# UNITED STATES PATENT AND TRADEMARK OFFICE

## Office Action Summary

10/524,811

## **DETAILED ACTION**

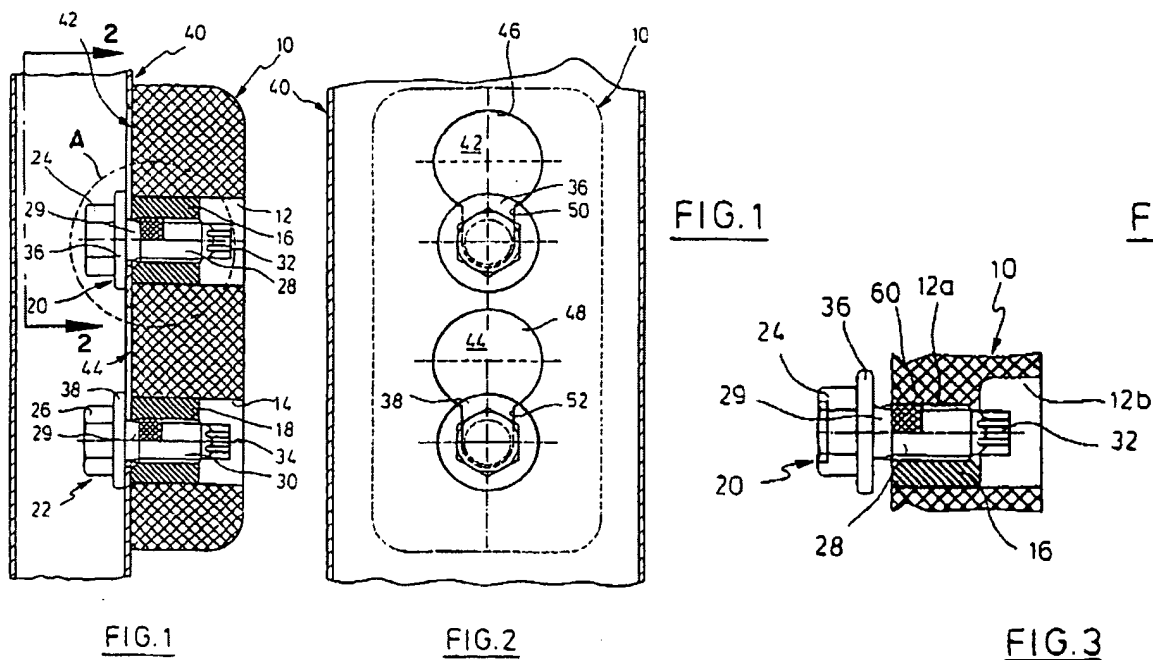
a self-locking (Column 3 lines 18-23, copied below) bolt 20 configured to be screwed into bushing such that it is guided with the head (24,36 is considered the head) through the larger opening (Fig 2) and head engages behind the smaller cut out, said bolt having tool engagement surfaces 32 at an end of the shank 28, and the head is round and has a smooth surface (at least 36 is round and has a smooth surface). Note that "36" is considered part of the head, and "36" is clearly the surface of the head that

is opposite (directly across from is assumed) the shank, not "24". "36" is round and has a smooth surface.

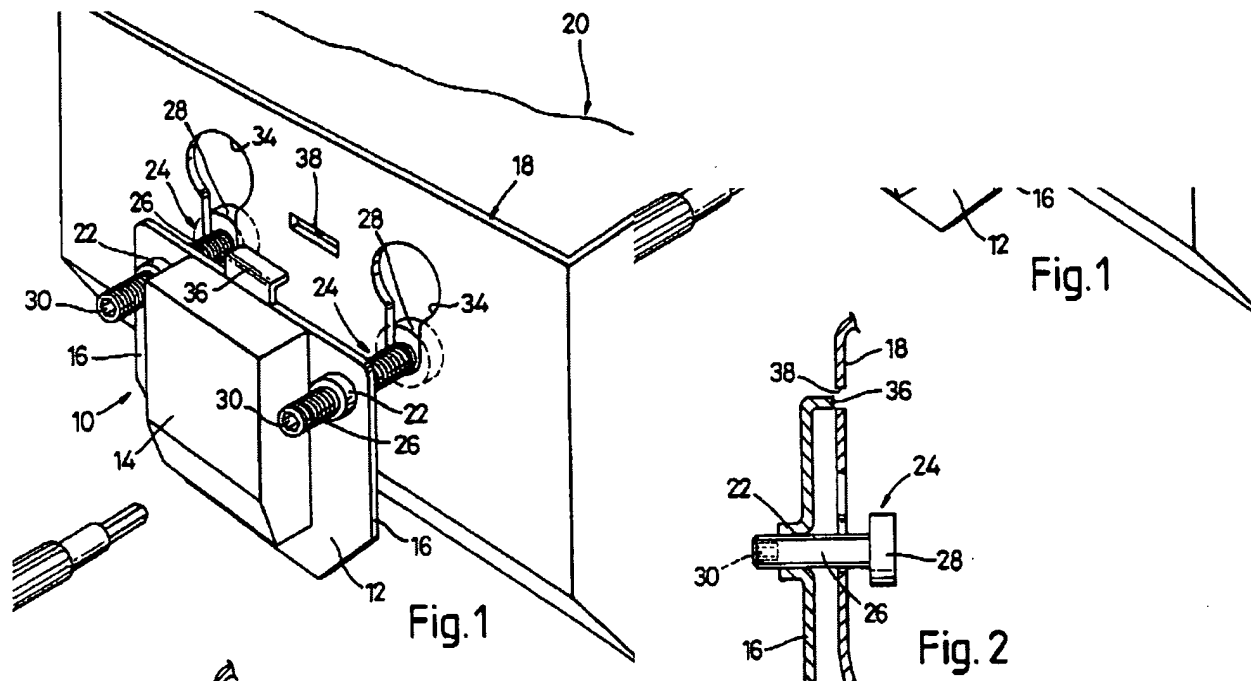
Re claim 17: The fasteners are described as threaded shanks in Column 2:

Threaded fasteners 20, 22 are provided with a head 24, 26, threaded shanks 28, 30 and ends 32, 34. The threaded shank 28, 30 are threaded into the inner threads of the inserts 16, 18. The ends 32, 34 of the shanks 28, 30 each have a Torx-portion. The heads 24, 26 have integrally formed radial flanges 36, 38. A non-threaded portion 29 joins the heads 24, 26.
